Appendix K – Review of Longwall Pillar Designs at UBB

December 8, 2010

SUBJECT: Review of Longwall Pillar Designs at Performance Coal Company,
Upper Big Branch Mine-South, Raleigh County, West Virginia,
MSHA I. D. No. 46-08436

Appendix 2
Location of UBB AMSS Evaluations

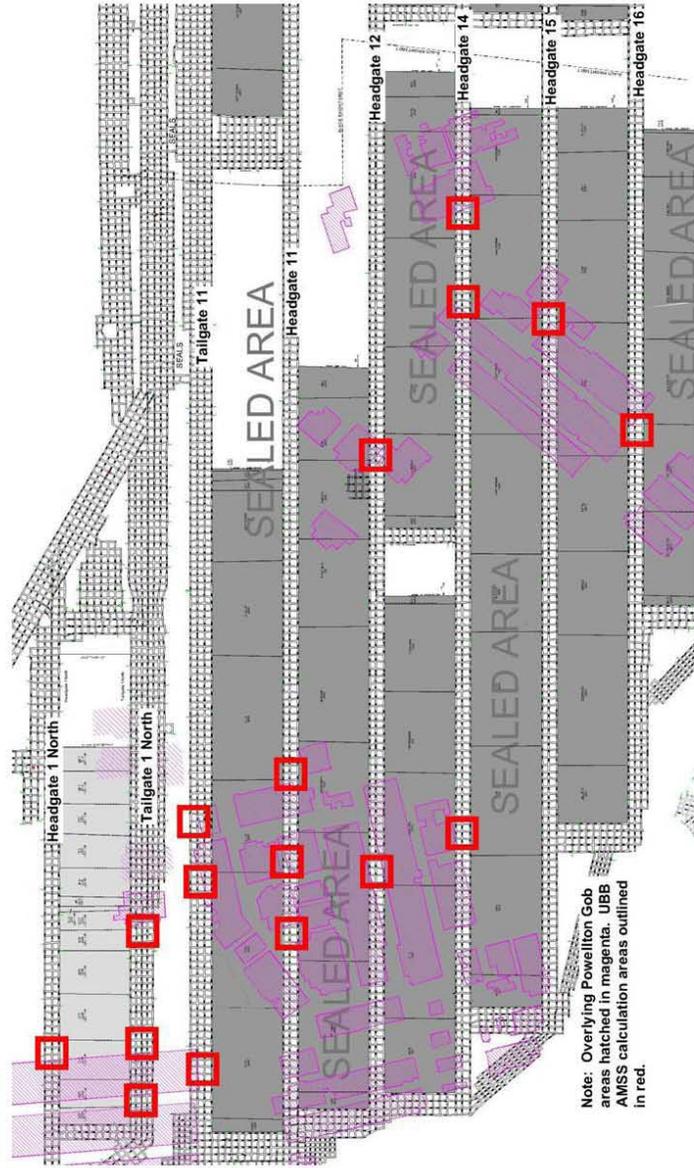
to ascertain if additional roof and/or rib support may be needed. The roof/rib support assessment is referred to as a local stability assessment. The AMSS local stability outputs are coded as green, yellow, and red. The green and yellow codes generated for the UBB analyses are defined in the following memo tables. The AMSS analyses are conducted for specific localized areas where stress concentrations from the other seam will affect a particular area of the mine. In the case for UBB, it will be Powellton gob boundaries impacting the UBB longwall gate pillars. The areas where the AMSS analyses were conducted are outline in Appendix 2 which is a map of the UBB workings.
